13" TRACK STOP INTERFERENCE – FIELD BULLETIN

ECN ID #	ECN 4679
DATE	April 29, 2025
BRAND	AGI, Westfield, Hutchinson, Mayrath
MODEL	MKX21384/94/114, HX213114, X213114
DATE RANGE	February 2025 – April 2025
DETAILS	Some 13" auger tracks have been found to have the track stop holes punched off-centre, causing the track stop to contact the lift assist during operation.

Figure 1 Off centered punched holes on track stop

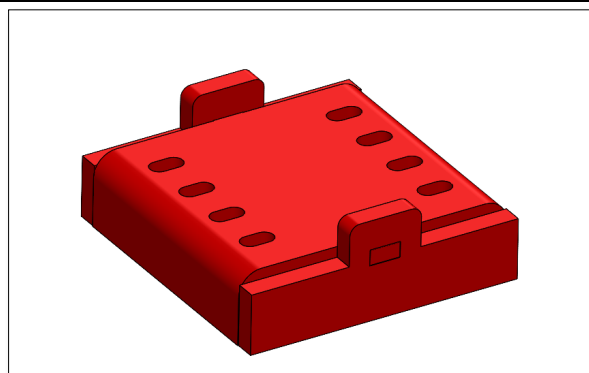
We have observed that on some 13" tubes, the holes for the track stop are punched off-centre. The affected tube bundles are 202623BK/SR/YL and 202622BK/SR/YL. Figure 1 illustrates the off-centre holes.

Check any tube bundles within the specified date range and measure the offset distance of the track holes. To do this, measure from the edge of the track to the edge of the hole. A deviation less than 1/16" is acceptable and requires no further action. A deviation between 1/16" up to 3/16" requires a new, updated version of the track stop, as shown in figure 2. If the deviation exceeds 3/16", contact customer service, as additional action may be required.

The part number for the track stop is 10-20296 – MKX130-84/94/114 TRACK STOP. Use existing hardware to mount track stop. Make sure the track stop is properly centered after mounting.
